ADMINISTRATIVE APPROVAL (LS) ADD2010-00079

ADMINISTRATIVE APPROVAL  
LEE COUNTY, FLORIDA

WHEREAS, Florida SE, Inc. filed an application for administrative approval to a Mixed Use Planned Development (MPD) on a project known as Coconut Point MPD to:

LOT SPLIT SITE PLAN - PROPOSED LOT #8  
EXHIBIT B-2.A.1

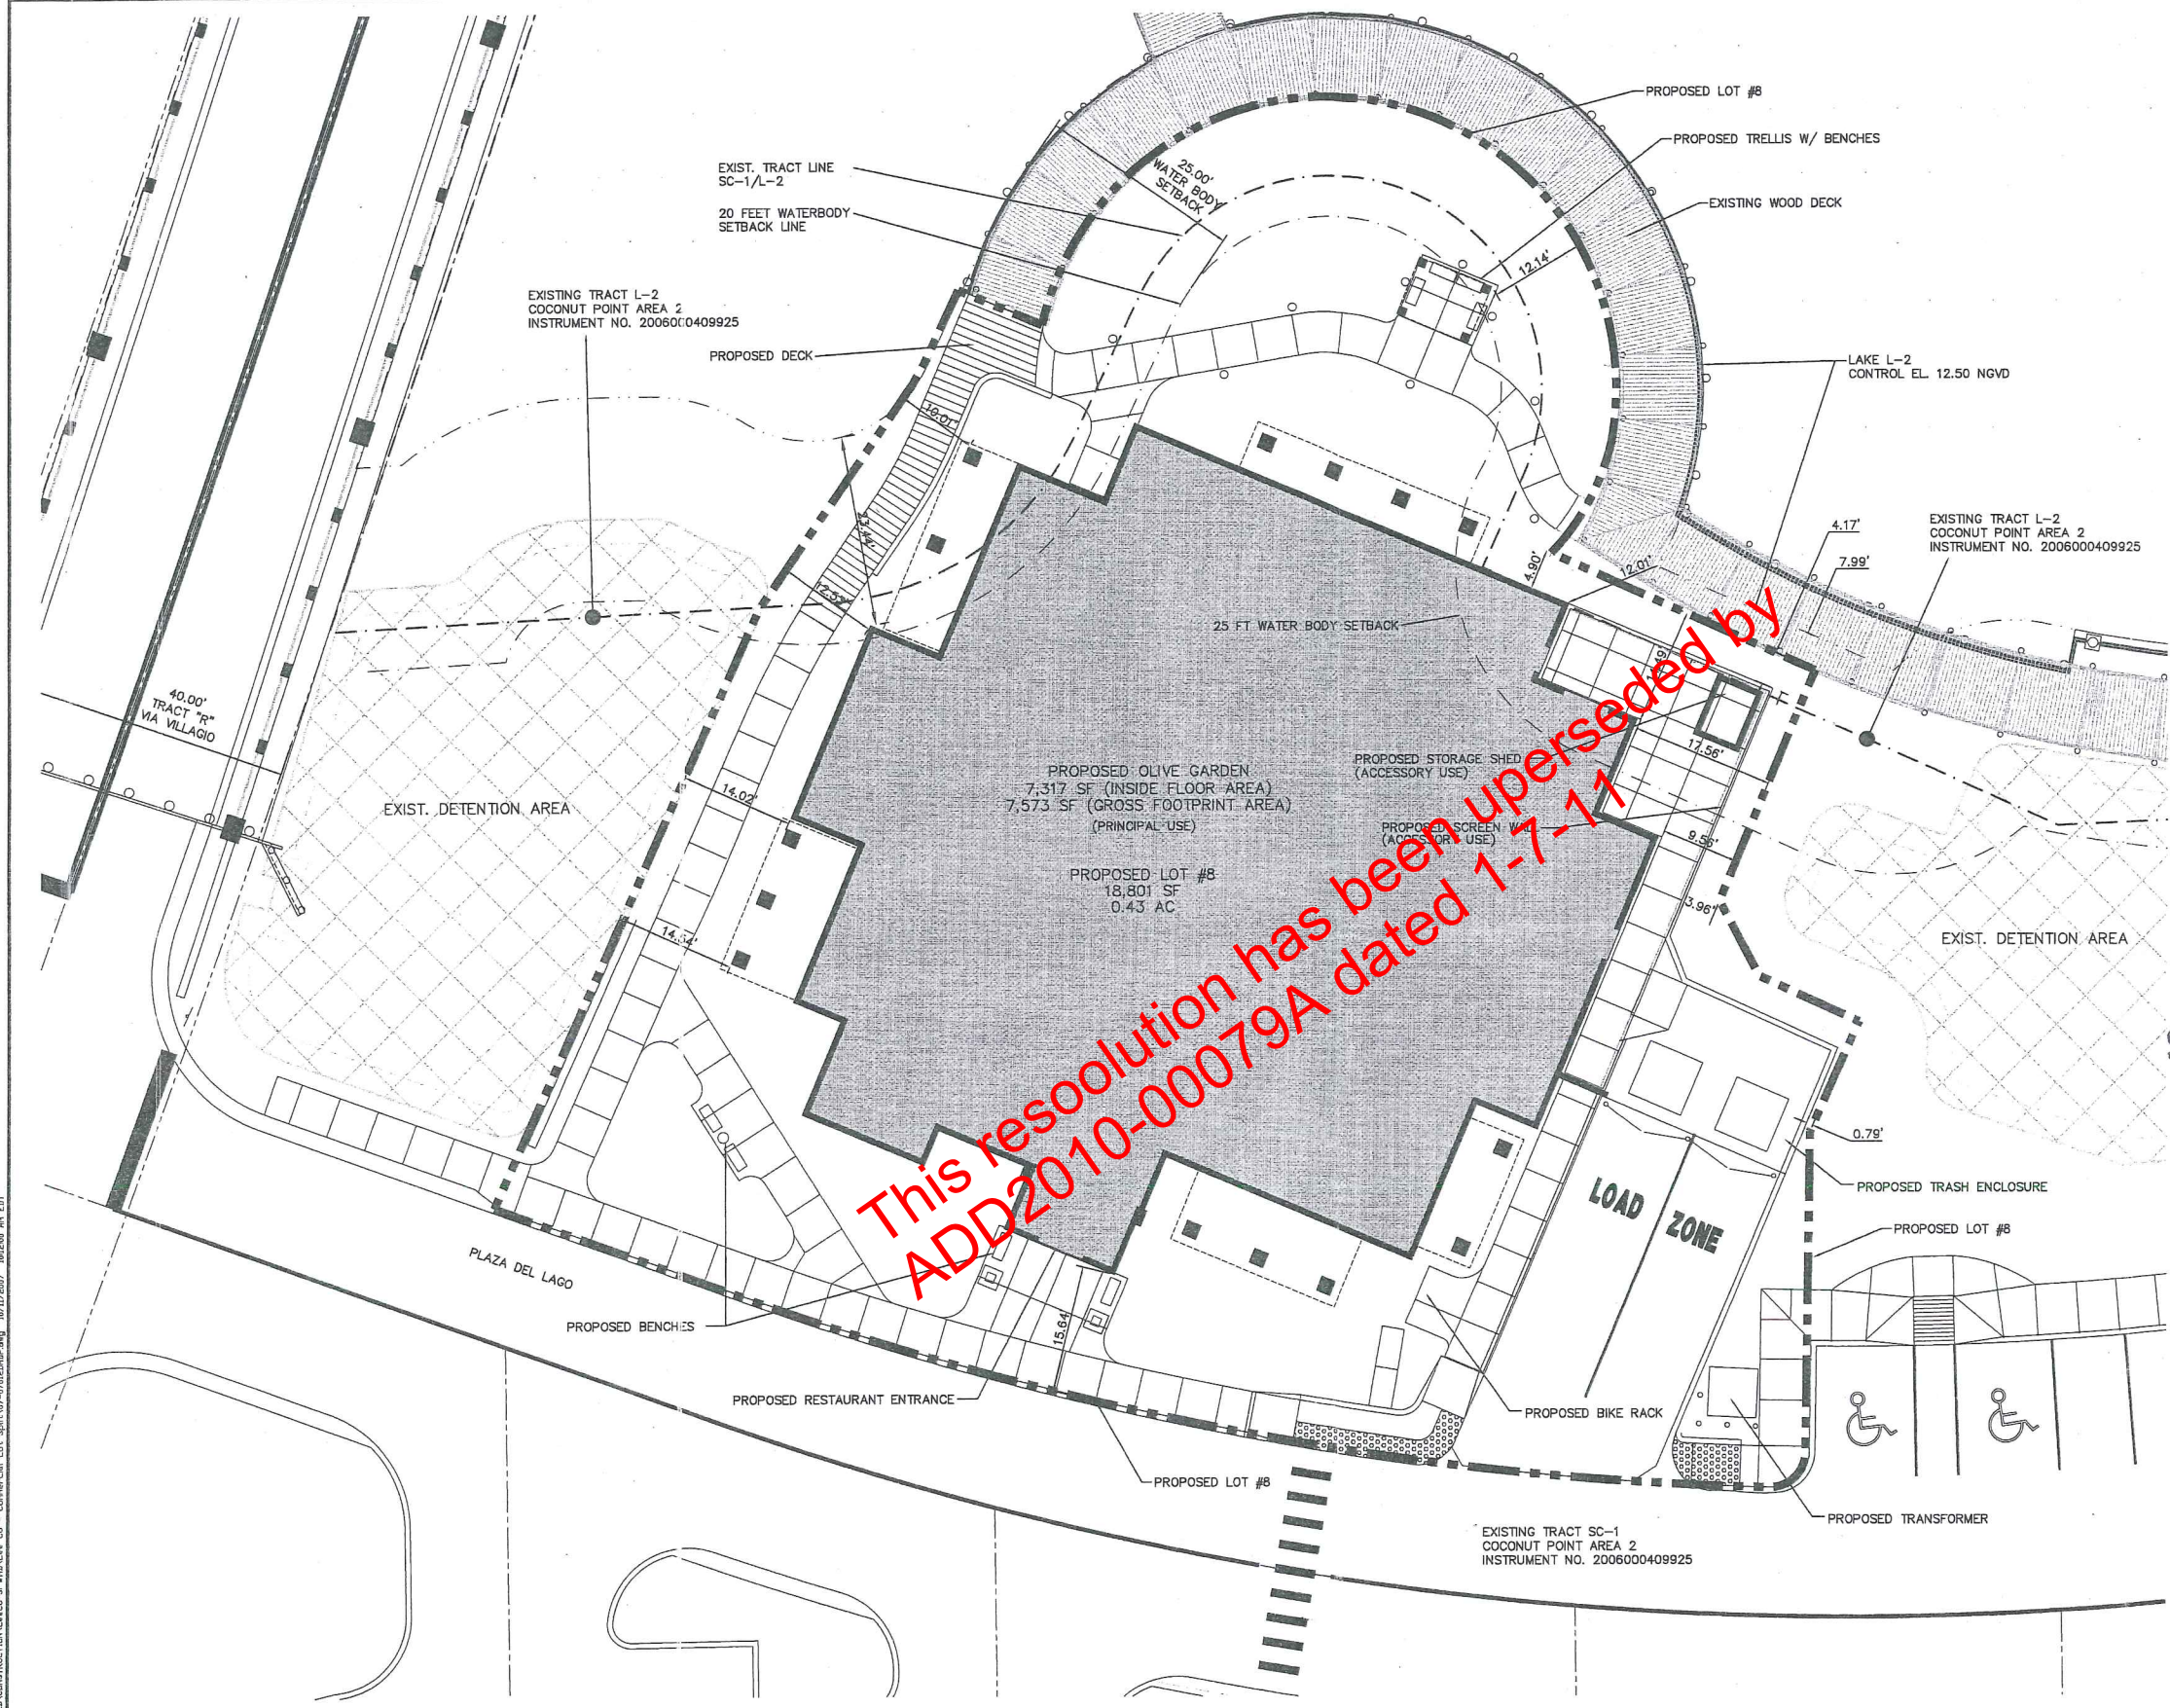
- a) A decrease in minimum required lot width from 100 feet to 68.83 feet;
  - b) A decrease in minimum required lot area from 20,000 square feet to 18,801 square feet;

- c) An increase in minimum lot coverage from 40 percent to 40.3 percent;
  - d) A decrease in minimum front (street) setback from 25 feet to 15.64 feet;

- e) A decrease in minimum side setback from 10 feet to 0.79 feet;
  - f) A decrease in minimum rear setback from 25 feet to 4.18 feet; and
  - g) A decrease in minimum waterbody setback from 25 feet to 7.81 feet.

WHEREAS, the applicant is proposing to develop a restaurant with a 7,573 square foot footprint on the proposed Lot #8 (see Lot Split Plan, attachment B); and

- a) A decrease in minimum required lot width from 100 feet to 68.83 feet;
  - b) A decrease in minimum required lot area from 20,000 square feet to 18,801 square feet;

- c) An increase in minimum lot coverage from 40 percent to 40.3 percent;
  - d) A decrease in minimum front (street) setback from 25 feet to 15.64 feet;

- e) A decrease in minimum side setback from 10 feet to 0.79 feet;
  - f) A decrease in minimum rear setback from 25 feet to 4.18 feet; and
  - g) A decrease in minimum waterbody setback from 25 feet to 7.81 feet.

MIN.(ADD2004-00060)	MIN. REQUESTED	ACTUAL DESIGN
FRONT(STREET):	25 FT	15 FT	15.64 FT
SIDE:	10 FT	0.5 FT	0.79 FT
REAR:	25 FT	4 FT	4.90 FT
REAR (ACCESSORY):	5 FT	4 FT	4.17 FT
REAR (WATERBODY):	25 FT	9.5 FT	10.01 FT
REAR (WATERBODY, ACC.):	20 FT	7.5 FT	7.99 FT

COCONUT POINT - AREA 2  
PHASE 1 - COMMUNITY CENTER  
PBA 1 & 2  
LAKE SHOPS PLAN

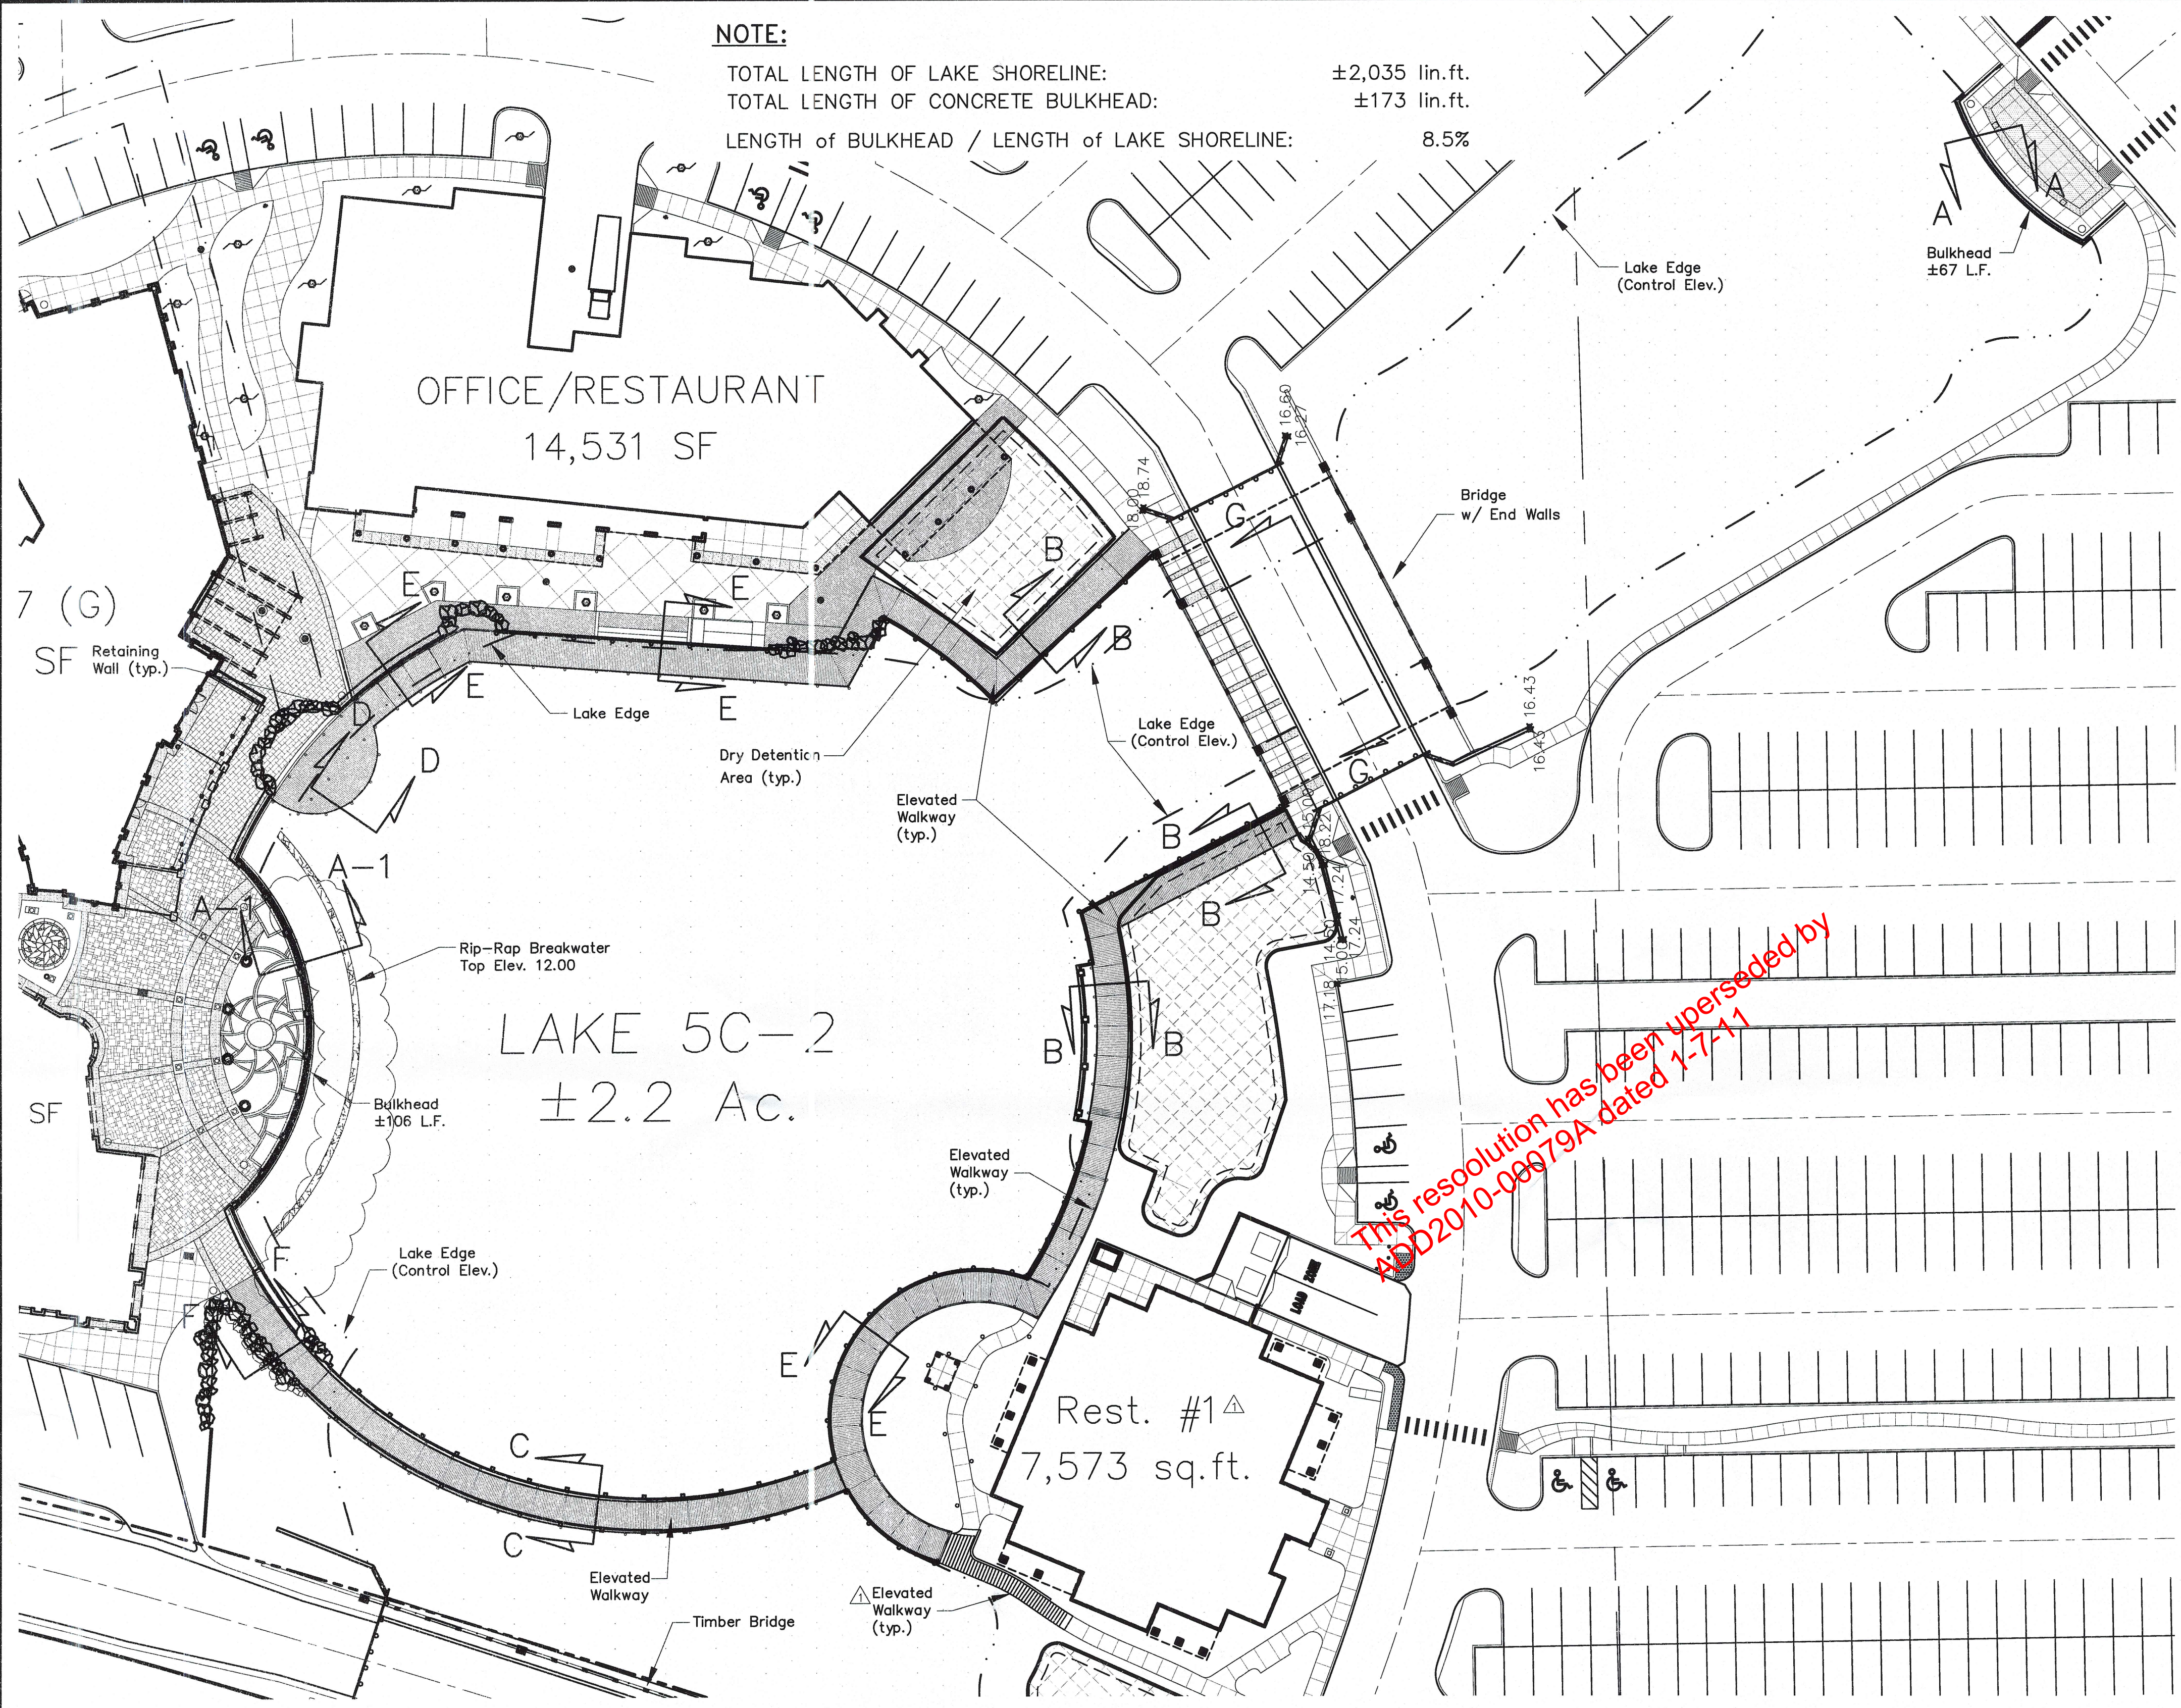
- 3) Revise the Bulkhead Details exhibit approved under ADD2004-00060 to replace a portion of rock retaining wall in order to install an elevated walkway on the west side of the proposed building.

WHEREAS, the applicant is requesting to revise the Bulkhead Details exhibit approved under ADD2004-00060 to replace a portion of rock retaining wall in order to install an elevated walkway on the west side of the proposed building as depicted on the Lake Shops Plan stamped RECEIVED OCTOBER 19, 2010 COMMUNITY DEVELOPMENT (see Attachment C); and

WHEREAS, the replacement of the rock retaining wall and installation of an elevated walkway will allow the pedestrian walkway across the lake to connect to an existing walkway on the south side of the proposed Lot #8; and

WHEREAS, the plan approved by ADD2004-00060 included 28.3% of the lake in bulkhead and the revised plan now includes 8.5% bulkhead; and

3. **The Bulkhead Details exhibit approved by ADD2004-00060 is replaced in full by the Lake Shops Plan stamped RECEIVED OCT 19 2010 COMMUNITY DEVELOPMENT (see Attachment C).**

NOTE:  
TOTAL LENGTH OF LAKE SHORELINE: ±2,035 lin.ft.  
TOTAL LENGTH OF CONCRETE BULKHEAD: ±173 lin.ft.  
LENGTH of BULKHEAD / LENGTH of LAKE SHORELINE: 8.5%
